SUNDRY NOTICES AND REPORTS ON WELLS

TRAVIS FEDERAL 2B

CFM Oil Company
NMNM23417: Travis Federal 2B
330' FNL & 2310' FEL Sec. 13, T18S-R28E
Eddy County, New Mexico

RE: Plugging and Abandonment Requirements, Conditions of Approval

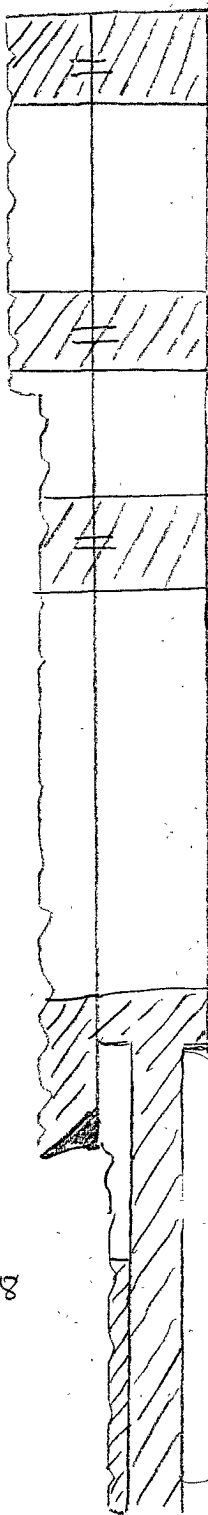
1. RIH and tag PBTD between 2700'-2680' +/- . Spot a plug from PBTD – 2235'. WOC and tag no lower than 2235' (covers bottom hole, 7" shoe, and 5-1/2" liner top).
2. Perforate the 7" casing @ 827', squeeze with adequate cmt to fill 100' in/out of 7" casing (covers the base of salt). WOC and tag no lower than 727'.
3. Perforate the 7" casing @ 396', squeeze with adequate cmt to fill 100' in/out of 7" casing (covers the top of salt). WOC and tag no lower than 296.
4. Perforate the 7" casing @ 60', circulate cmt to surface in/out of the 7" casing. WOC and top off as needed.

12 1/4" hole drilled
to 425

Set 8 5/8" mudded
in. Pulled after
Setting 7"

Perf @ 60' circ. in/out

TDS @ 345
Perf @ 395' SQ 395 - 295'
WOC Tag

BOS @ 777
Perf @ 827 SQ 827 - 727
WOC Tag

8 1/8" hole CTDC 2146'
liner Top 2285

7" @ 2570'
Cmt. w/ 50 SX

CTDC
2608

ABTD - 2235'
54.1575
cutt

5 1/2" liner 2680

CM. 20 SX, TD 2700

Tag PBTD Being Cmt.
TO 2235 WOC Tag,
est. 50 SX.
